Applicant: Joel THOMSON  
Serial No.: 10/764,760  
Filed: January 26, 2004  
Page 8

**Amendments to the Drawings**

Figure 4

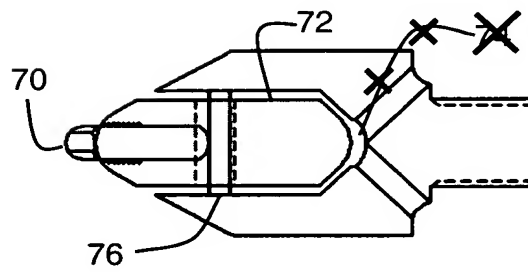
Section 5 of the Office Action objected to the drawings under 37 C.F.R. §1.84(p)(5) because the drawings include a reference character not mentioned in the description. More

specifically, the Office Action required corrected drawing sheets in which reference character "74" is removed from the figures.

Please replace the original drawing sheet "2/2" containing Figs. 3-5 with the Replacement Sheet attached as Exhibit A. The Replacement Sheet includes Fig. 4 in which reference number "74" and the corresponding lead line have been removed as shown in the Annotated Sheet Showing Changes accompanying the Replacement Sheet. Figs. 3 and 5 on the Replacement Sheet are unchanged from the original drawing sheet.

Applicant hereinabove has amended Fig. 4, the only figure which includes reference character "74", to remove both the reference character and the corresponding lead line. A Replacement Sheet with corrected Fig. 4 and unchanged Figs. 3 and 5 is attached as Exhibit A. An Annotated Sheet Showing Changes accompanies the Replacement Sheet in Exhibit A.
